Gatwick Airport Northern Runway Project

Statement of Common Ground Between Gatwick Airport Limited and Environment Agency – Tracked Version

VERSION: 3.0

DATE: AUGUST 2024

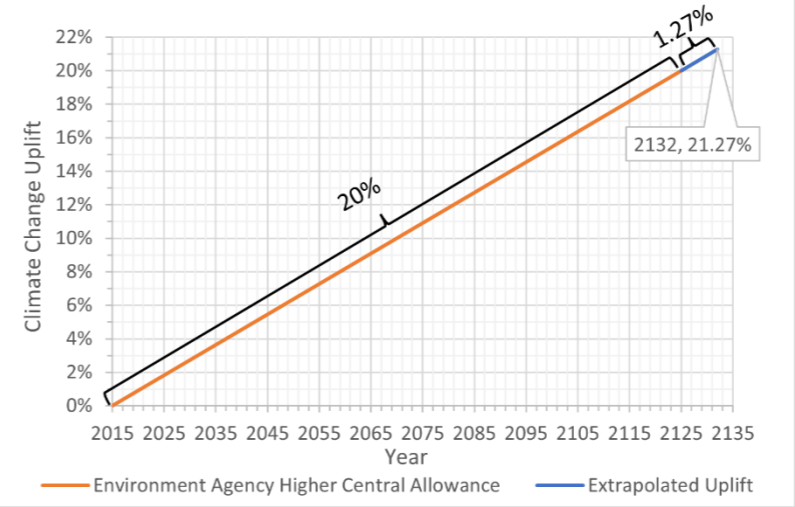
2.22.2.1	ES Appendix 11.9.6 Flood Risk Assessment	<p>The document states climate change and the associated increase in peak river flows for the River Mole Management catchment. Table 3.7.1 is reflective of the most up to date peak river flow climate change allowances from 2022. The applicant should consider the impact of climate change, clearly stating the development lifetime over which the assessment has been made.</p> <p>Updated position (Deadline 5) We note the submission of an updated fluvial modelling report to support the operation and functionality of the proposed Flood Compensation Areas. We would wish to review the FCA Delivery Plan. update to the fluvial modelling report and response to the queries below prior to agreeing this point, so we would consider 2.22.2.1 as still Under Discussion.</p> <p>The adopted lifetime for the airfield works is given as 40 years. During previous discussion, the applicant highlighted that although these have been assigned a 40-year lifetime, consideration of these elements as part of the wider 100 year lifetime for the overall development has also been undertaken. We request confirmation on this.</p> <p>In addition, it is noted the first full year of opening is considered to be 2032, giving the surface access work an adopted lifetime of 100 years up to 2132. We note the climate change figures for the 2080's epoch cover the period up to the year 2125. We require confirmation what consideration has been given to the time period between 2125 and the first full year of opening in relation to the design of the flood compensation/mitigation strategy.</p> <p>Relating to the adopted lifetime of the airfield works of 40 years, we have requested further information on why this lifetime was chosen and whether the airfield works are considered within the overall flood mitigation for the site which has a 100 year design life.</p> <p>Updated Position (Deadline 9)</p>	<p>The incorporation of the predicted impact of climate change is addressed in Section 3.7 of the FRA. The adopted lifetime for the airfield works of 40 years (up to 2069), and the adopted lifetime of the surface access works is 100 years (up to 2132).</p> <p>The fluvial and surface water flood risk assessment of the Project and its mitigation strategies were completed using the +20%/25% climate change uplift for the Central allowance, as well as +40% uplift for the Upper End allowance in accordance with Environment Agency guidance.</p> <p>Section 7 of the FRA demonstrates that through the provision of additional attenuation storage, floodplain connections (syphons) and floodplain compensatory storage the Project will not increase flood risk to other parties for its lifetime taking climate change into account.</p> <p>A Technical Note will be provided to the EA for discussion.</p> <p>Updated Position (Deadline 5): The Floodplain Compensation Area Delivery Plan (FCDP) and an update to the fluvial modelling report (ES Appendix 11.9.6 – Annex 5) will describe the philosophy and functionality of the proposed River Mole diversion and the two FCAs and the relationship of proposed works with these. The FCDP will be submitted to examination at Deadline 5, and the fluvial modelling report was shared with the EA in advance of Deadline 5 on 17 May 2024.</p> <p>Project design life: GAL met with the EA on 23 May 2024 to discuss the rationale for the airfield component of the Northern Runway Project being given a design life of 40 years. At this it was explained that the combination of the fluvial flood storage provided by the River Mole and the proposed FCAs at Museum Field and Car Park X will provide off-site flood protection in excess of 100 years plus 40% climate change (the credible maximum scenario)</p>	<p>ES Appendix 11.9.6: Flood Risk Assessment [REP6-053APP-147]</p> <p>The Applicant's Response to Deadline 7 Submissions (Doc Ref. 10.65)</p>	<p>Under discussion Agreed</p>

Reference	Matter	Stakeholder Position	Gatwick Airport Limited Position	Signposting	Status
		<p>The applicant has added additional information to Appendix 11.9.6: Flood Risk Assessment (FRA) with the latest being Version 3.0 dated June 2024. This document contains an expanded Executive Summary which includes further information on the choice of lifetimes for the proposed development, and importantly, confirmation that the project as a whole considers the 100-year lifetime for the purposes of the management of flood risk.</p> <p>Further information has been provided by the applicant regarding climate change for peak river flow and the 100-year lifetime of the development. Previously, the applicant has suggested using the 40% uplift as a proxy to consider the 7 years beyond 2125, up to 2132. The applicant has now also linearly extrapolated the higher central allowance of 20% for the additional 7 years to 2132, with the result a suggested 1.27% uplift. Although it would be useful to see some additional detail on this extrapolation, such as more description on methodology or the information in a graphical format within the Flood Risk Assessment (FRA), this additional work suggests the use of the 40% uplift as a proxy is reasonable to consider the additional 7 years lifetime of the development</p> <p>Updated Position August 2024 The addition of further explanation on the extrapolation methodology and the addition of a graph to visually depict how the uplift has been calculated is welcomed.</p>	<p>for the Project as a whole – i.e. to beyond 2025. The FRA will be updated to make this clearer and shared with the EA for comment in advance of formal submission to the examination at Deadline 6.</p> <p>Updated Position July 2024 The Applicant submitted an updated FRA at Deadline 6 [REP6-053] which clarifies Gatwick’s position in relation to the issues raised. Further clarification regarding the consideration of climate change between 2125 and 2132 is also provided within The Applicant’s Response to Deadline 7 Submissions shared at Deadline 8.</p> <p>Updated Position August 2024 The Environment Agency’s climate change allowances use 2015 as the baseline. Therefore, to extrapolate the climate change uplift for the additional 7 years beyond 2125 to 2132, the 20 per cent Higher Central climate change allowance for the 2080s epoch was first divided by 110, the number of years between 2015 and 2125. This annual uplift was then multiplied by 7 to estimate the total potential uplift over a 7-year period, 1.27 per cent. The potential uplift between 2015 and 2132 is illustrated in the graphic below.</p>
